**IMPERIAL METALS CORPORATION
MT. POLLEY PROJECT**

**RESPONSE TO REVIEW COMMENTS
ON TAILINGS EMBANKMENT DESIGN
(REF. NO. 1625/6)**

JANUARY 25, 1996

SCALE AS SHOWN
DRG. NO. 1625.111
REV. 1

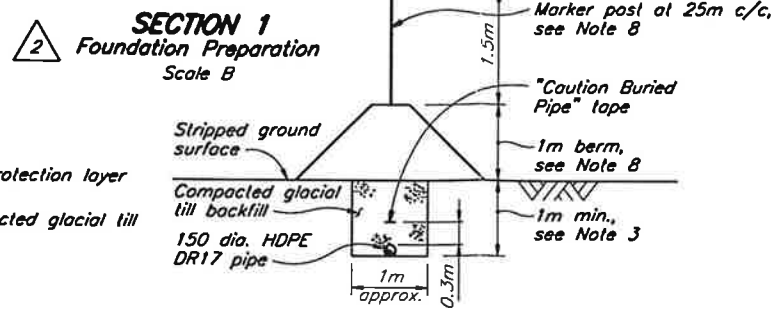
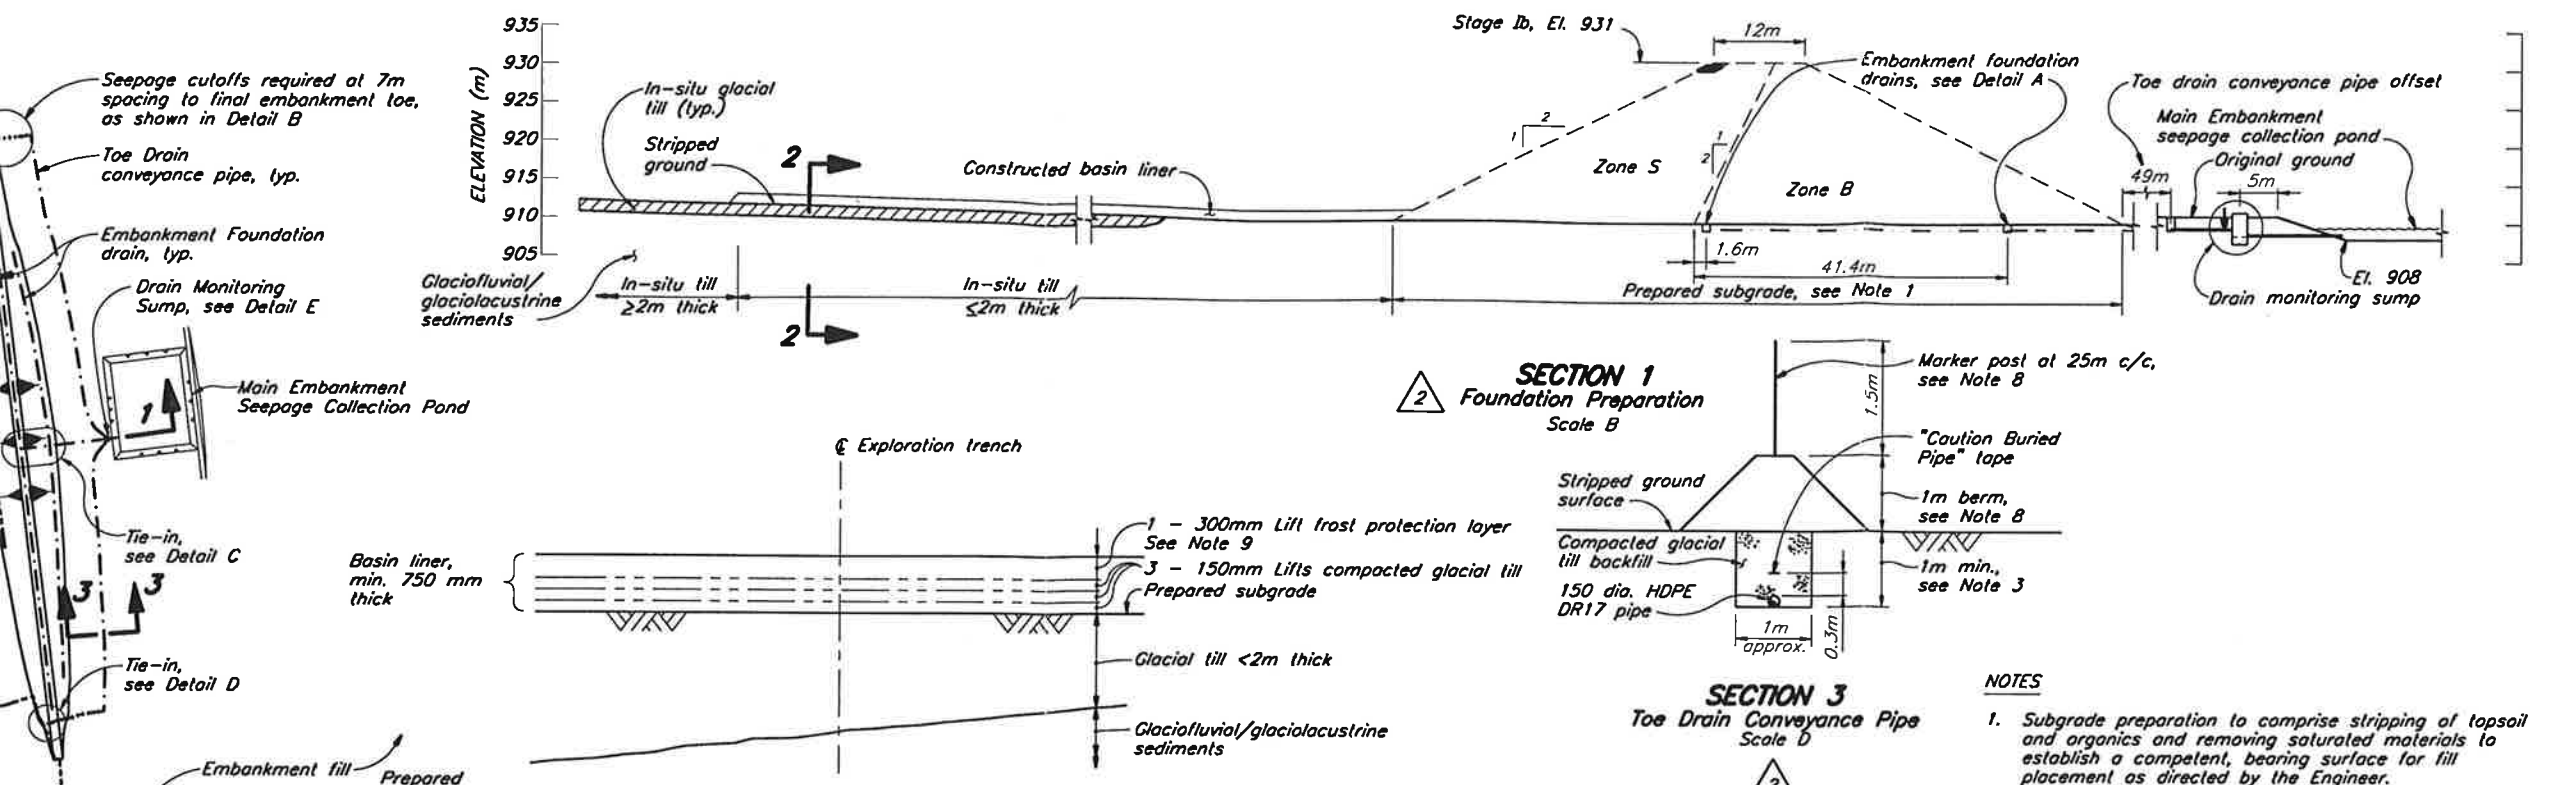
The design proposed entails some of the compacted main dam to be constructed over loose to medium dense tailings. With this design variability in consolidation characteristics would be expected. This could lead to tension cracks near the top of the main dam and generally parallel to C.L. Stability analysis should allow for 10 m deep tension cracks filled with water.

Vibratory compaction of the beach should also be considered for the beach zone in the zone downstream of the S.O.L. to ensure low compressibility results.

The modified centreline construction method is illustrated on Drawing 1625.111. As in the centreline construction method, the embankment fill zones extend onto the tailings beaches during each staged expansion. The tailings beaches will be comprised of sandy materials with a very high coefficient of consolidation. The compressibility of these materials will also be low and any settlements which result from on-going expansion of the embankment occur relatively rapidly and are complete during the construction period. In fact, one of the design requirements for each of the staged expansions on to the tailings beaches is for monitoring with vibrating wire piezometers in order to identify the development and dissipation of any excess pore pressures during construction. It has been our experience that any excess pore pressures which develop in the tailings tend to dissipate relatively quickly and the technical specifications include provisions for monitoring to ensure that the pore pressures have dissipated (and consolidation is therefore completed) prior to placement of each successive lift. Vibratory compaction of the first lift typically results in the largest pore pressure response in saturated tailings, after which successive lifts show progressively lower response to loading. The compressibility of the tailings decreases in response to the densification which results from loading and

DRG. NO. **510-12-02-1625.205** REV. **2**

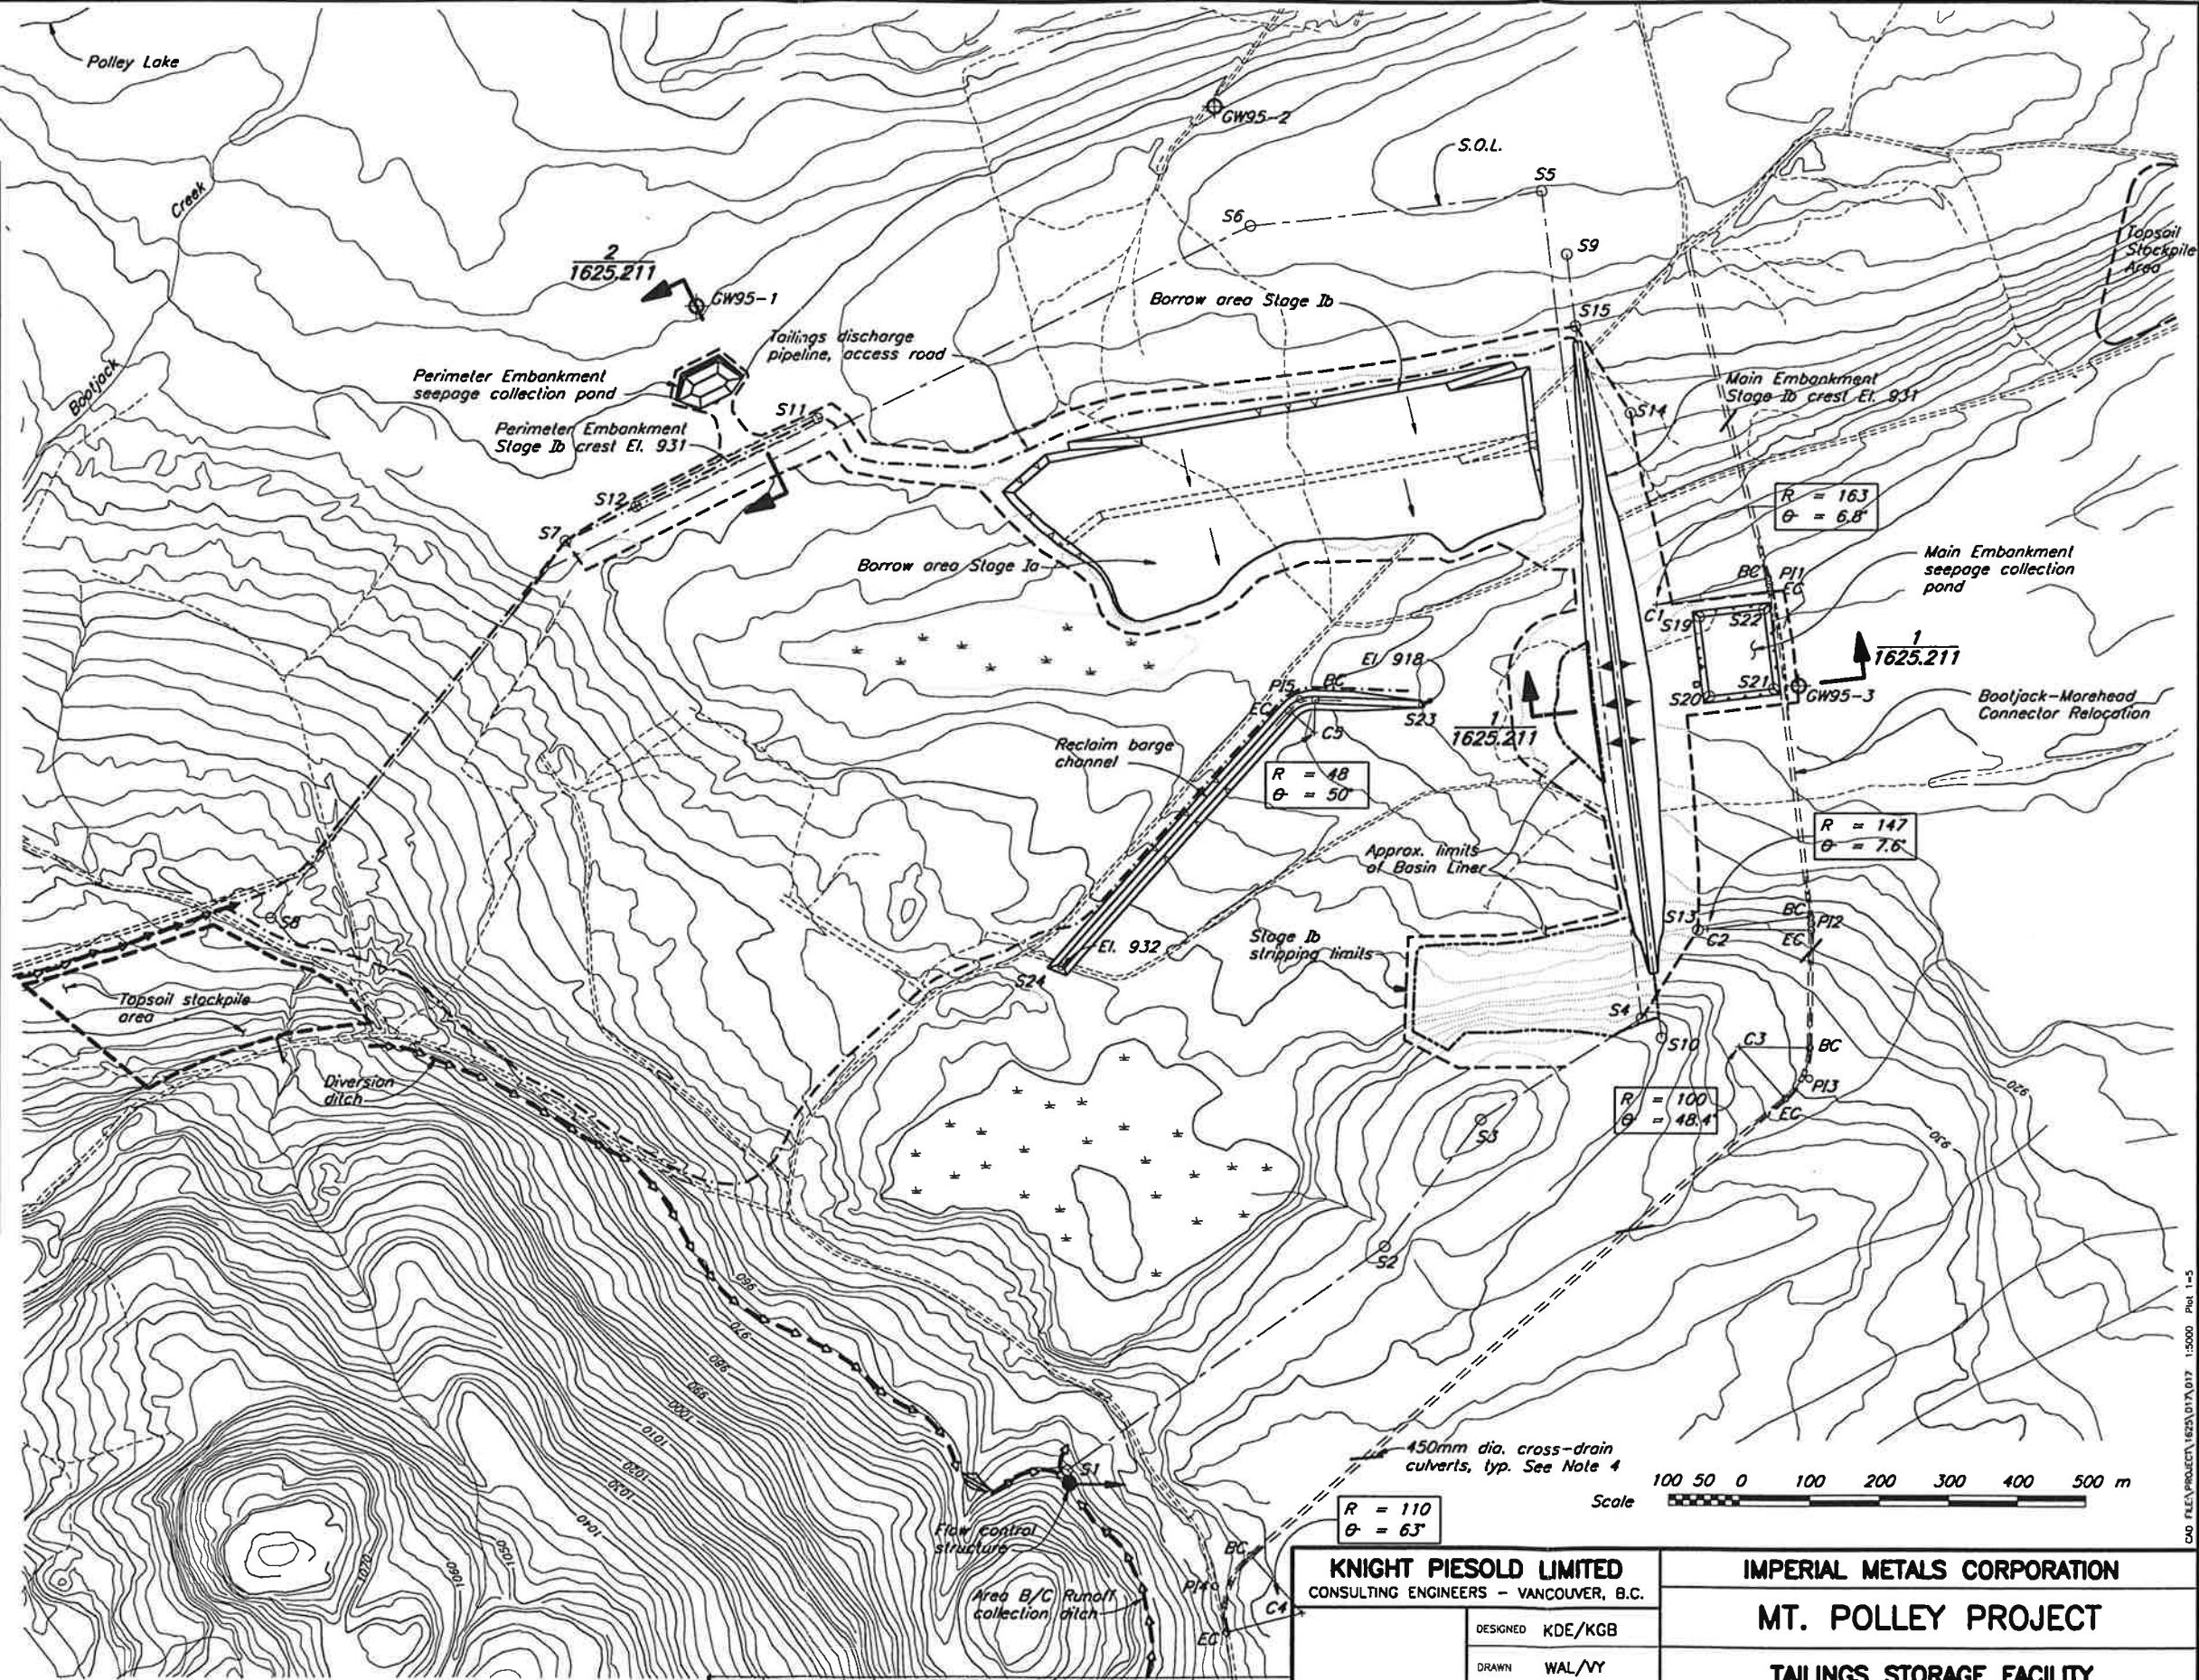
Provide the location of these wells. Several must be downstream. List test requirements.

Three permanent groundwater quality monitoring wells have been specified in the detailed design of the Tailings Storage Facility. The locations are shown on Drawing No. 510-12-02-1625.205. Additional monitoring wells will be installed as required during operations and as outlined in "Groundwater Monitoring Design Document" (Knight Piésold Ltd. Ref. No. 1625/5, May 19,1995).
